ADDENDUM NO. 2

March 1, 2022

**TIMOTHY BALL ELEMENTARY SCHOOL ADDITIONS, RENOVATIONS,
AND RELATED WORK
Crown Point, IN 46307**

This Addendum forms a part of and modifies the Bidding Requirements, Contract Forms, Contract Conditions, the Specifications, and the Drawings dated February 7, 2022 by Gibraltar Design. Acknowledge receipt of the Addendum in the space provided on the Bid Form. Failure to do so may subject the Bidder to disqualification.

S-411

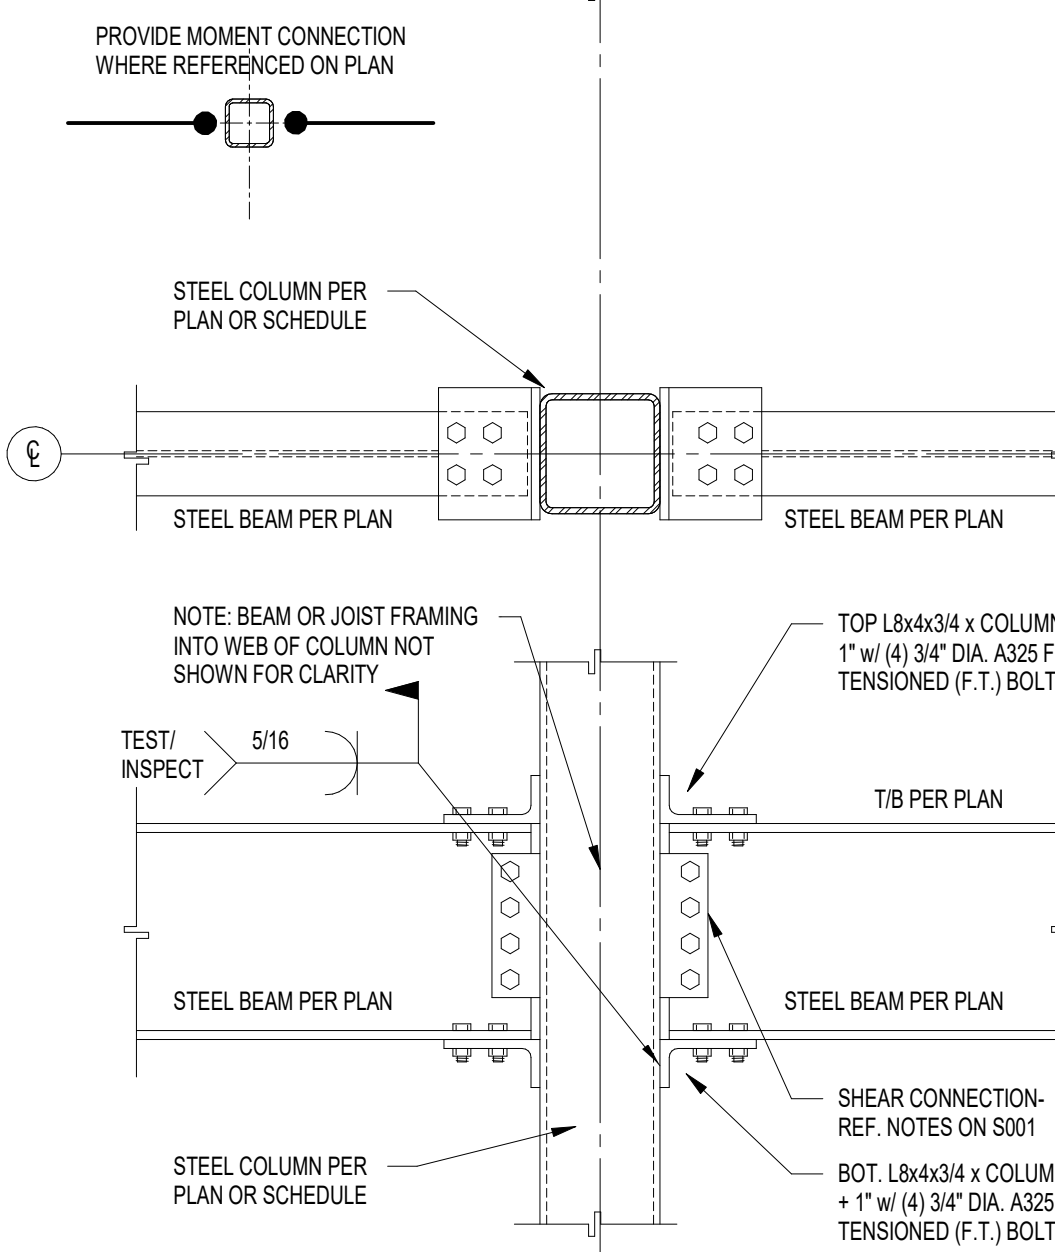
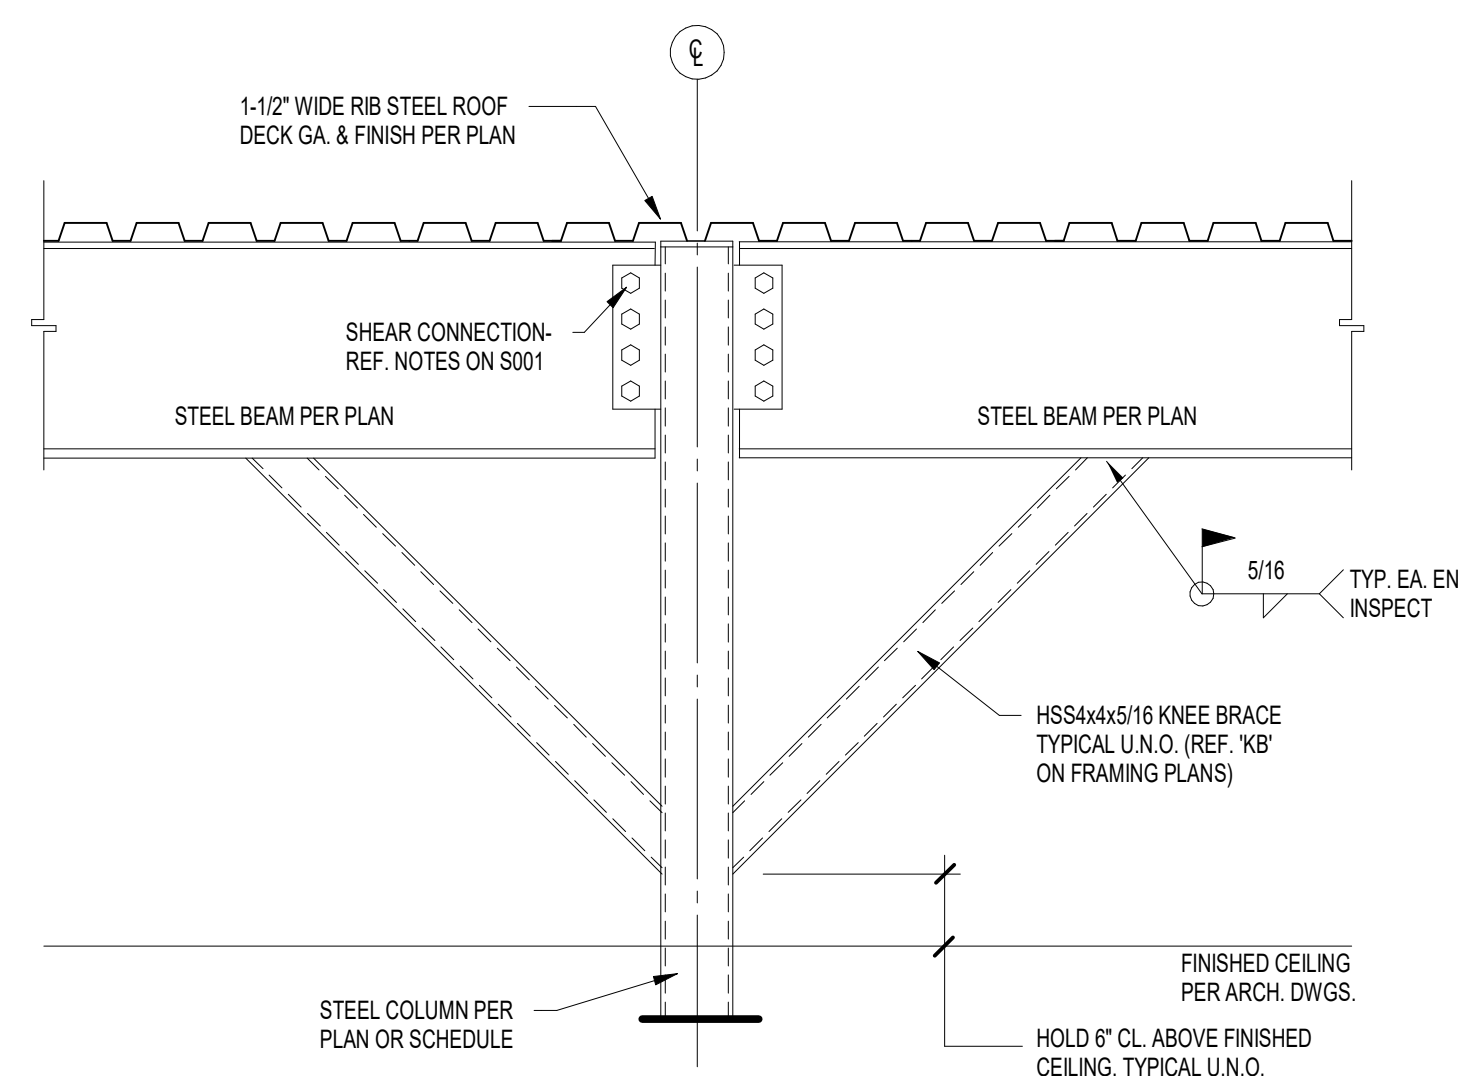
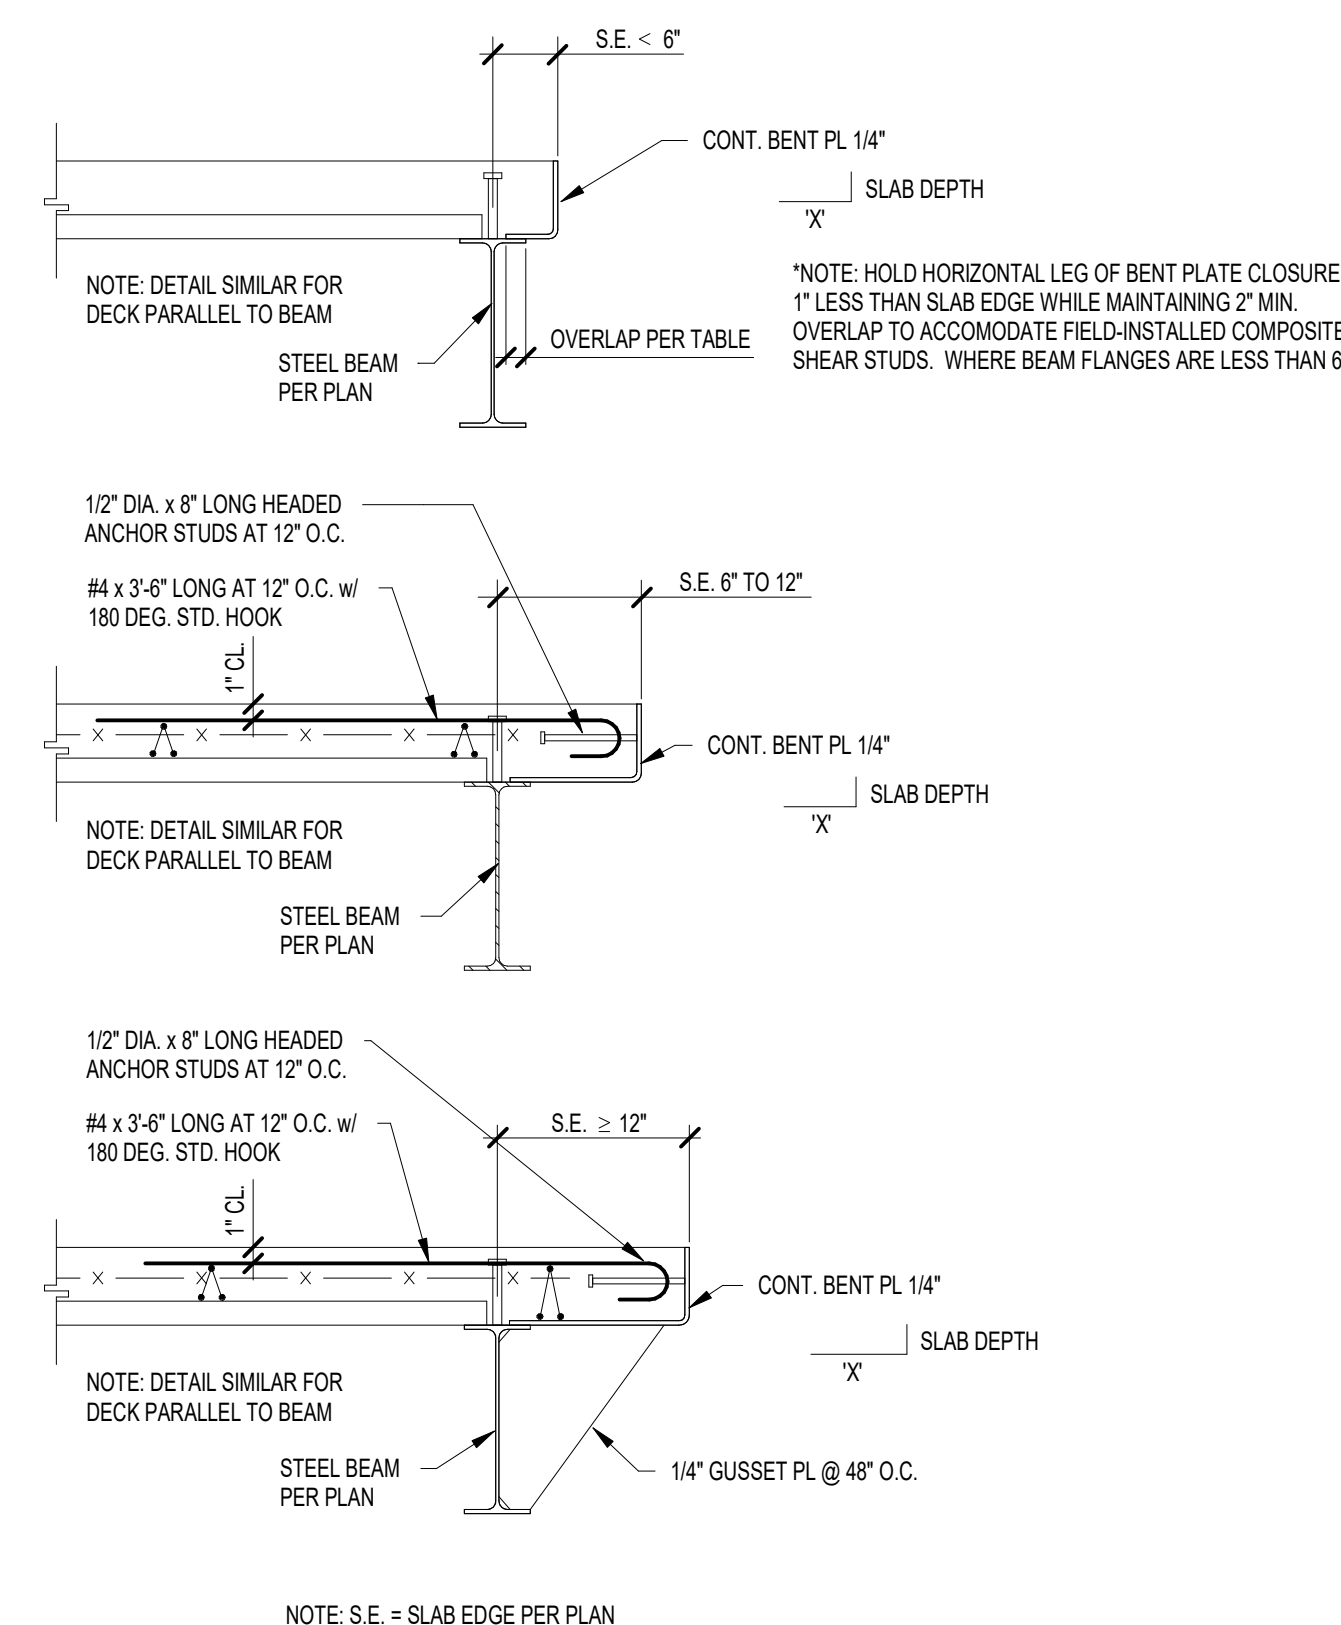
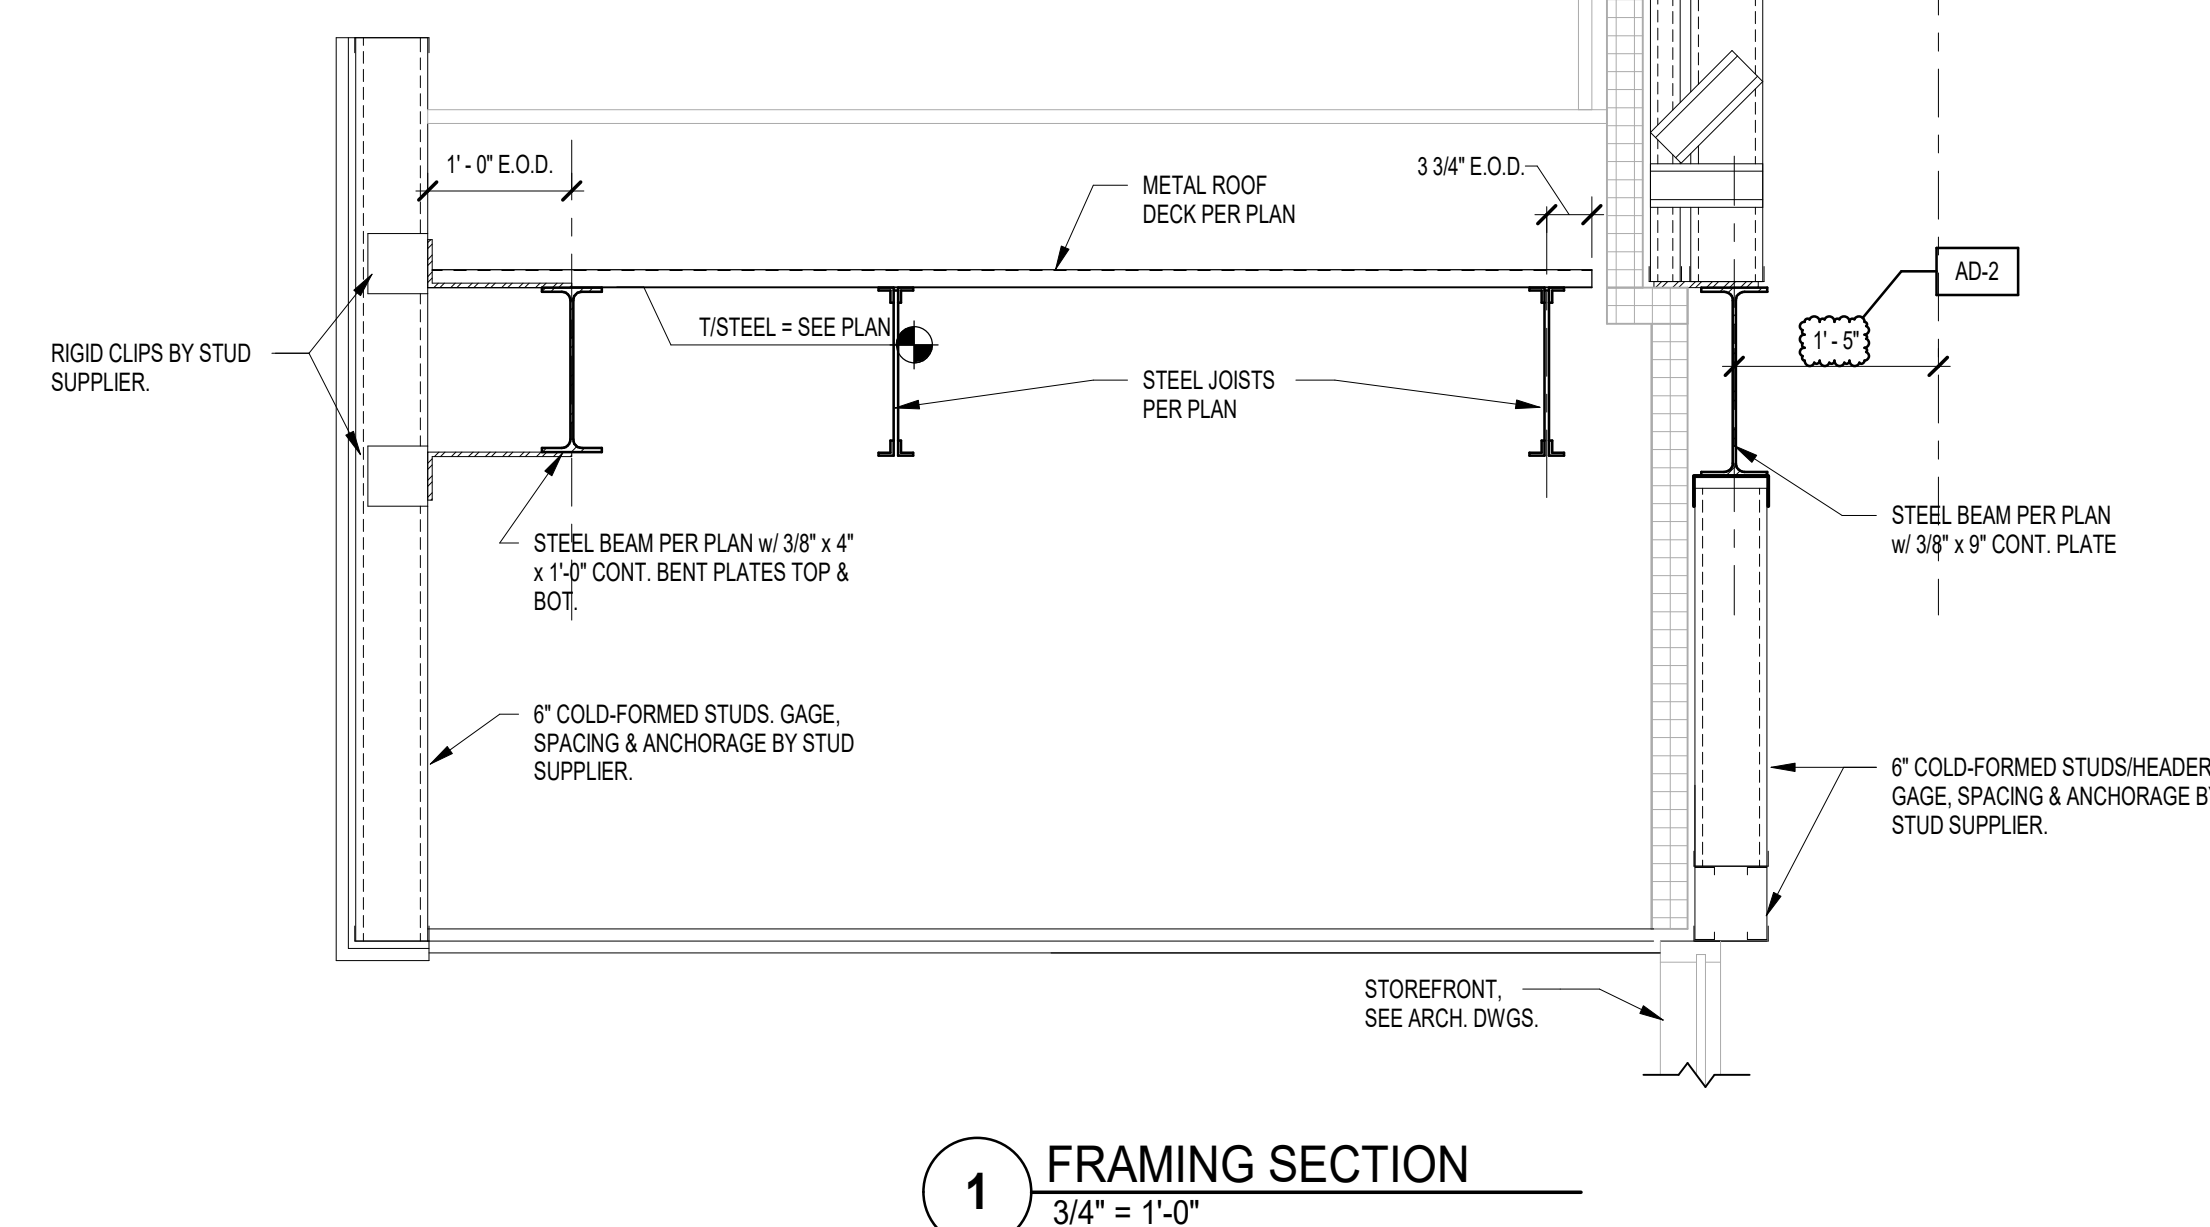
5. Sheet S-001, S-204, S-206, S-207, S-208, S-209, S-411, S-412, S-413

- A. Refer to revised, full size drawings, included in this Addendum, refer to bubbled revisions on each of the sheets.
